HISTORIC PRESERVATION COMMISSION
REGULAR MEETING
OCTOBER 24, 2019
ASSEMBLY HALL
395 MAGNOLIA RD.
PINEHURST, NORTH CAROLINA
4:00 PM

FINAL ORDER
VILLAGE OF PINEHURST
HISTORIC PRESERVATION COMMISSION

Applicant and owner Bart Boudreaux is requesting a Certificate of Appropriateness for an exterior modification to a historic property at 83 Short Road. The proposed exterior modification is the modification of the roof line. The property can be identified in the Moore County Tax Registry by Moore County PIN Number# 00017850.

Applicant Pinehurst Homes is requesting a Certificate of Appropriateness for an exterior modification to a historic property at 65 Cherokee Road. The proposed exterior modification is the modification of the rear roof line and addition of roofing to the left side porch of the outdoor storage addition (Garage). The property is owned by Michael and Moriah Brown can be identified in the Moore County Tax Registry by Moore County PIN Number #00014110.

SITELINE WOOD CSMS (L/ R) W/ 5" V SPREAD MULL
7/8" BEAD SDL W/ PERM WG
LITES PER DRAWING

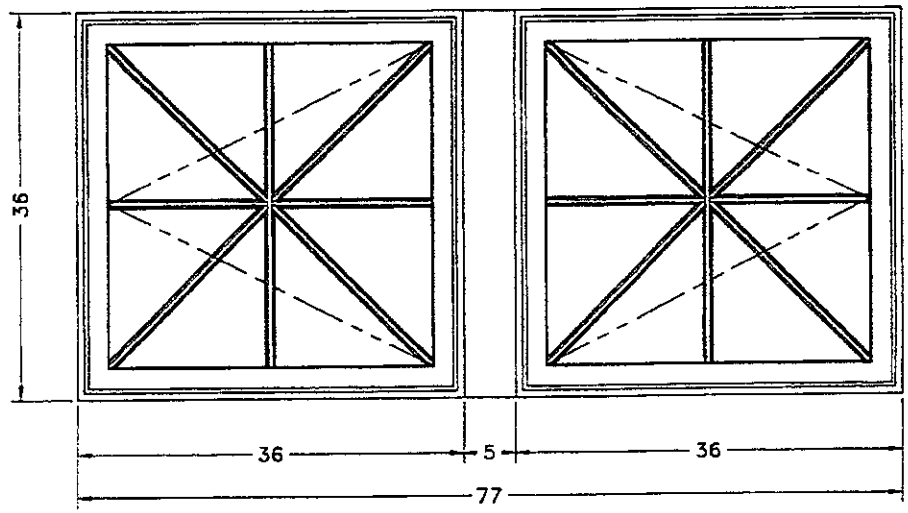
The applicant is proposing the addition of a window located on the second story of the home, within the boundaries of the existing gable, and on a street facing façade. The proposed window matches the design and material of existing windows on the property. Based on the submitted material and the intent to match material, the addition of this window would be both congruent with the structure and the historic district guidelines.

The applicant is proposing to add a window, which will match the design and material of existing windows on site.

The applicant is proposing to add a window that will match the existing shape, positioning, location, pattern, size, material, and detail of existing windows on site.

PROJECT NO: 19-57-509
DATE: 11/14/19
DRAWN BY: EJA
SCALE: 3/32"=1'-0"
TITLE: Front Elevation View
SHEET NO. OF TOTAL SHEETS:

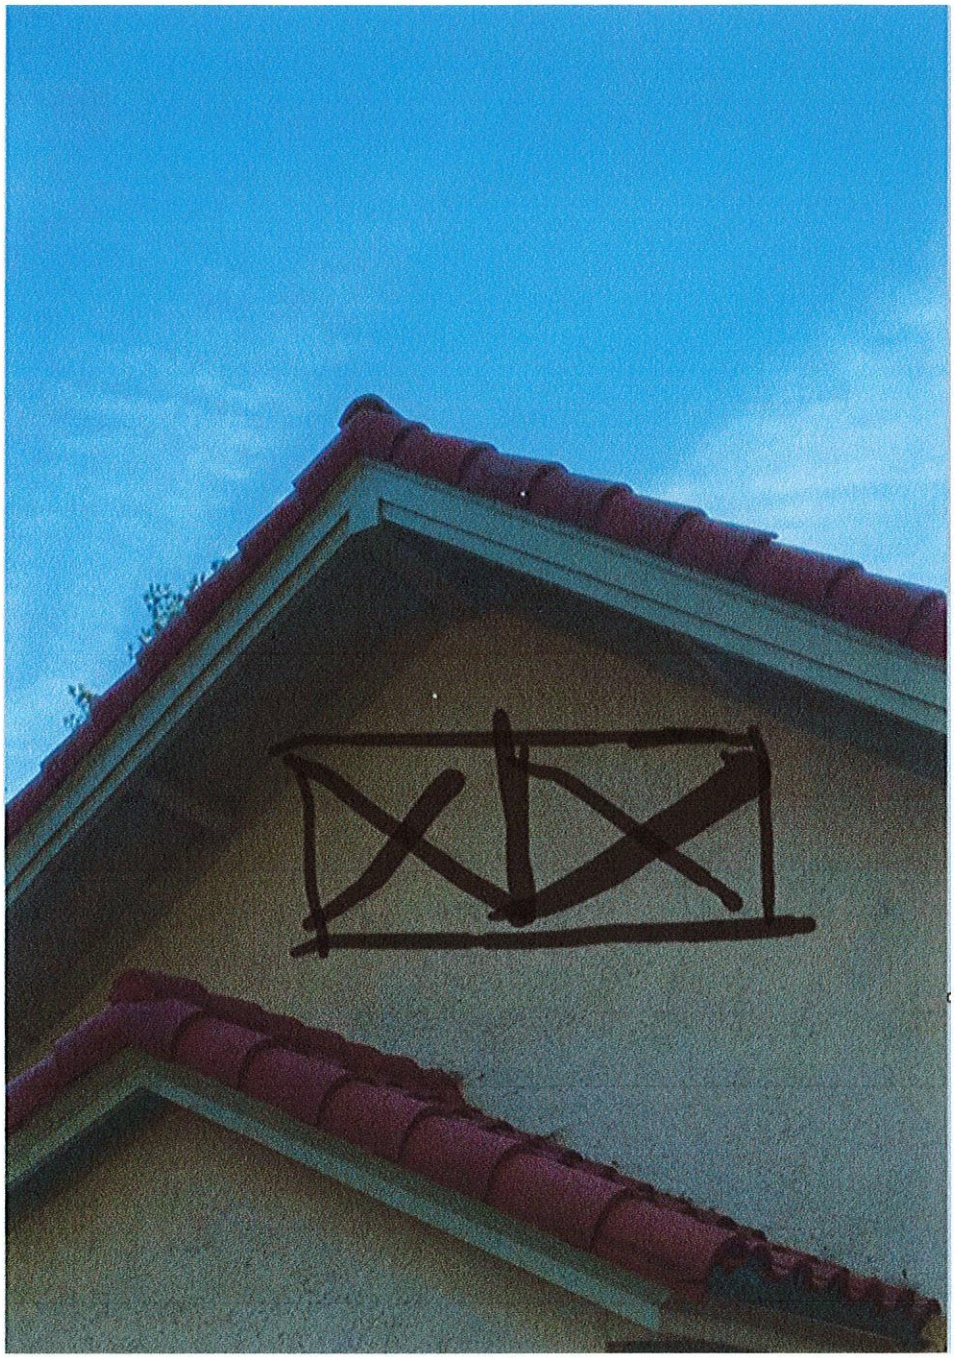
The structure located at 83 Short Road has a complicated roofline, as a result of multiple additions, resulting in multiple rooflines that conflict. The applicant is proposing to modify the roofline in two locations: (1) On the right elevation the applicant is proposing to raise the roofline of one of the previous additions to remove the current roof from intruding upon the livable space and (2) add additional roofing to the rear of the home to create congruency and compatibility with existing roofing.

The proposed modification to the right side elevation roofline will have a slightly raise and more uniform slope look compared to what is there now. This change in roofline will ultimately create a more consistent roofline appearance, therefore improving the structure's congruency with the Pinehurst Historic District.

PROJECT NO: 19-57-509
DATE: 11/14/19
DRAWN BY: EJA
SCALE: 3/32"=1'-0"
TITLE: Rear Elevation View
SHEET NO. OF TOTAL SHEETS:

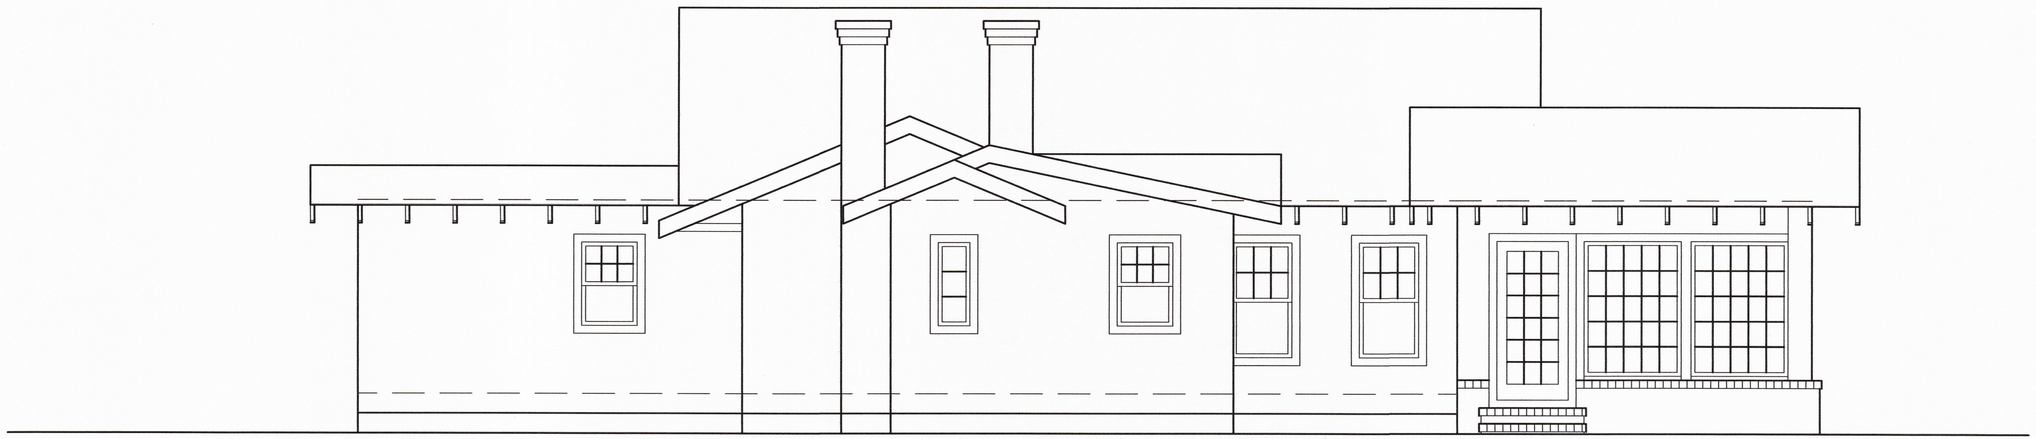
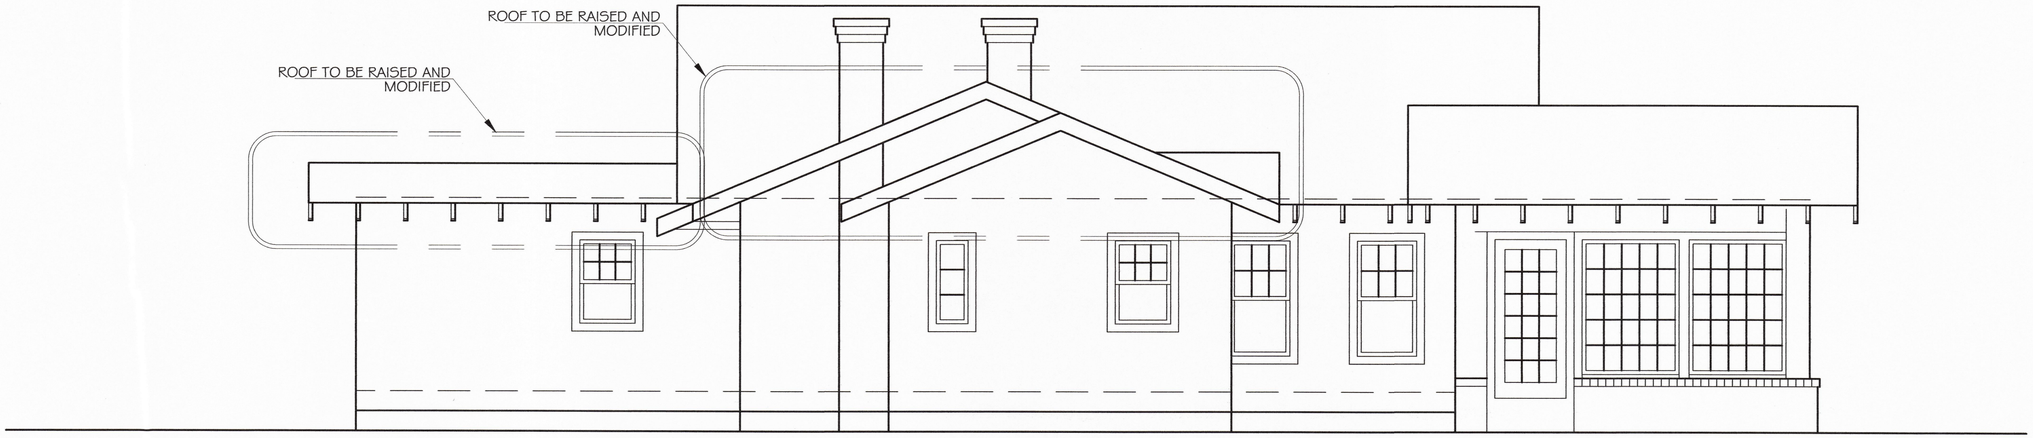
The rear roofline has multiple rooflines converging on each other from previous additions made to the structure. The proposed change to this rear roofline will modify and correct the existing roofline by creating a more consistent look to the roofline, which will be more in line with the character of the Pinehurst Historic District.

GARAGE EXTERIOR ELEVATIONS SCALE: ¼" = 1'-0"

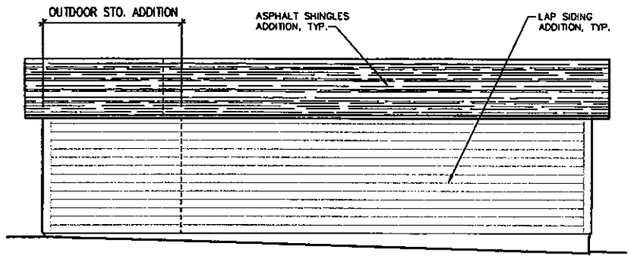
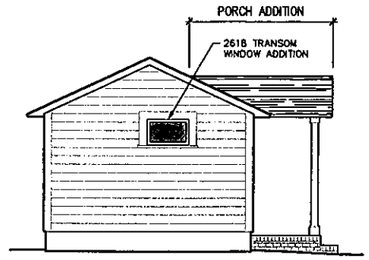
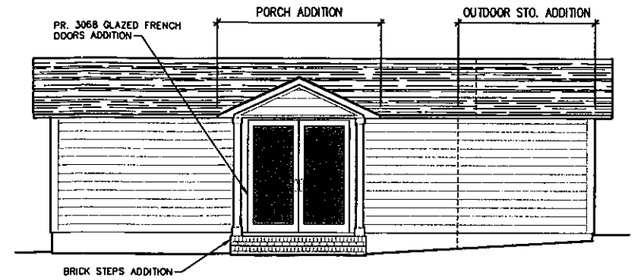
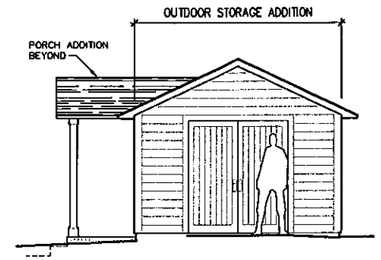
The applicant is also proposing to modify the roofline of the outdoor storage structure (garage) with the addition of roofing over an existing (previously approved) porch. The proposed roofing would match the material and style of the primary structure, which was approved to be black fiber glass shingles at the August 2019 meeting. The transition from an uncovered porch to a covered porch would not be compromise the compatibility with the primary structure or be incongruent with Pinehurst Historic District. The change would

The applicant is requesting a modification of a porch with the addition of roofing. The height as shown in the submitted drawings will not exceed the height of the existing roof line. The porch posts are proposed to be wood and the style is proposed to match the existing structure and what was previously approved in August 2019. The applicant did not propose a specific color of paint or stain.

HOUSE EXTERIOR ELEVATIONS SCALE: ¼" = 1'-0"

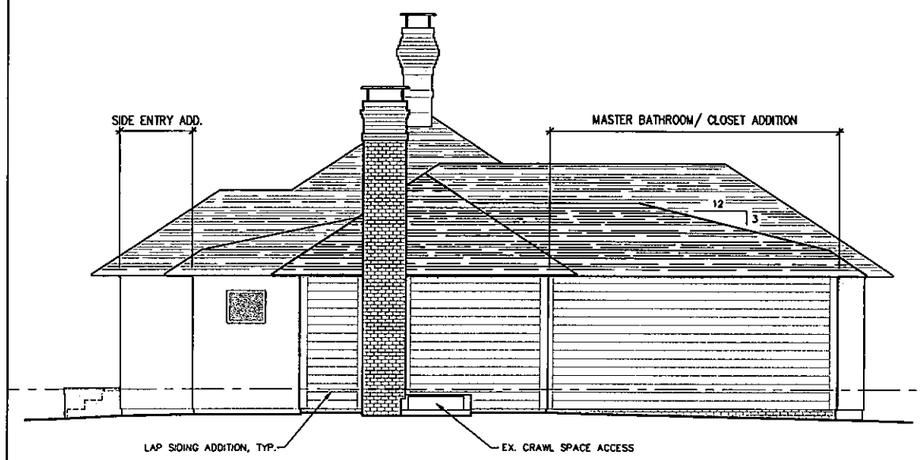
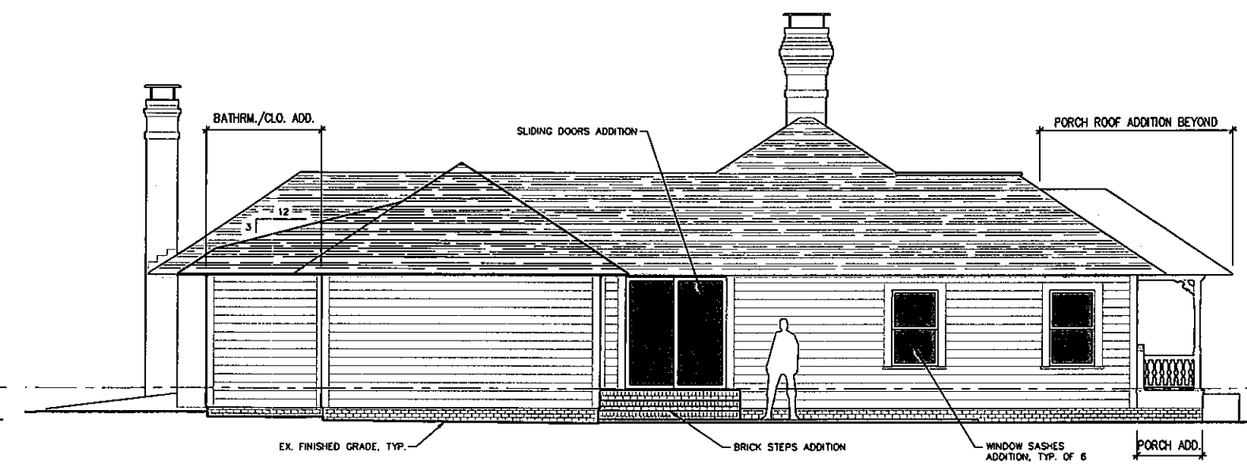
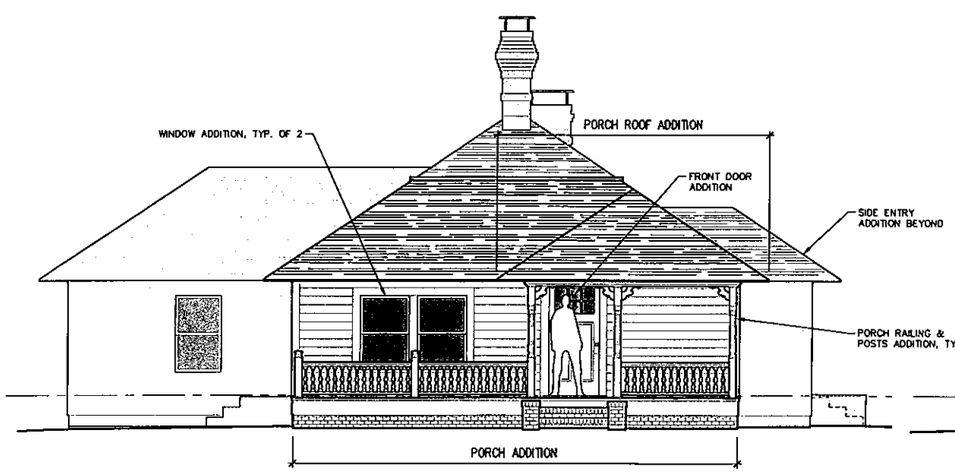
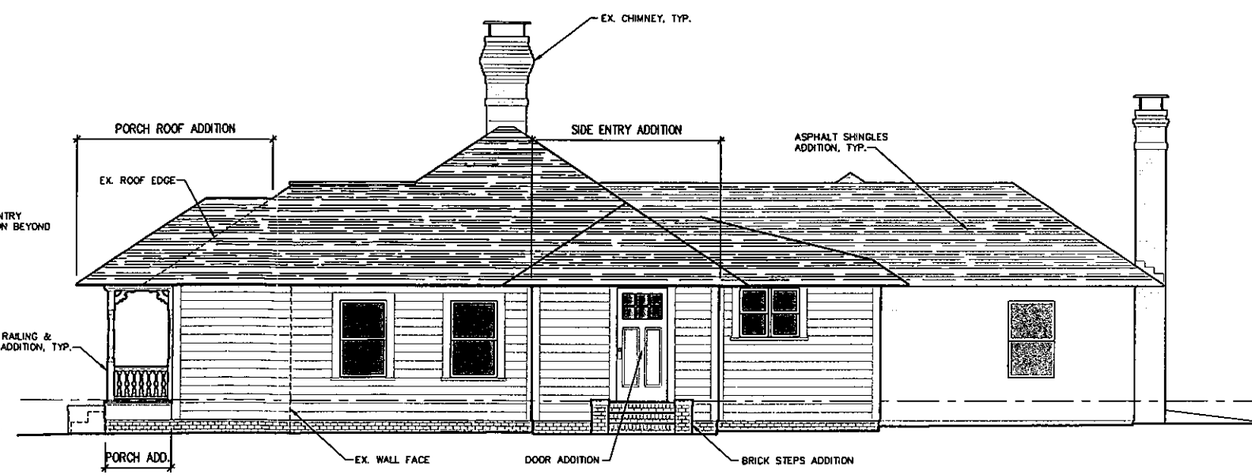
The applicant is proposing to modify the roofline of the previously approved rear addition of the main structure. The project was originally approved with a pitch of 4 over 12 and the applicant is now requesting a pitch of 3 over 12. This change in roof pitch would not negatively impact the character of structure or be incongruent with the Pinehurst Historic District.
